## ***Interactive comment on “Impacts of land use change and climate variations on annual inflow into Miyun Reservoir, Beijing, China” by J. K. Zheng et al.***

**J. K. Zheng et al.**

Received and published: 3 October 2015

Fig. 3. Figure 8.

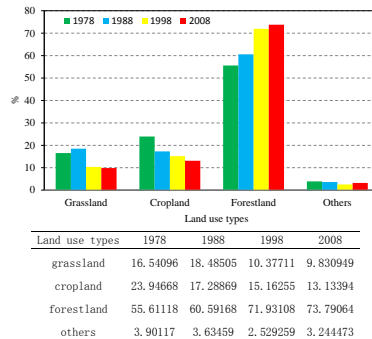
line 11-15, climate change in the future should be considered in designing watershed management strategies. For example, according to IPCC, the trends of precipitation and air temperature are required in designing water resource supply and allocation. "groundwater withdrawal" was replaced by "drinking water management". Figure 1, as the table above, latitude and longitude of 7 meteorological stations were described. Figure 2 (should be Figure 3), the reason lie in the paragraph under the table of this document. Figure 3 (should be Figure 4), four categories were used in the Figure. Reasons as followed. First, others including water area, residential area, and bare area, account for very small proportion of total area. Second, the manuscript focus on Ep. Others including water area, residential area, and bare area account for very small proportion of Total Ep. Figure 9, "the dashed line" have been replaced by "the thin line". "the solid line" have been replaced by "the bold line". "measured evapotranspiration" have been deleted.
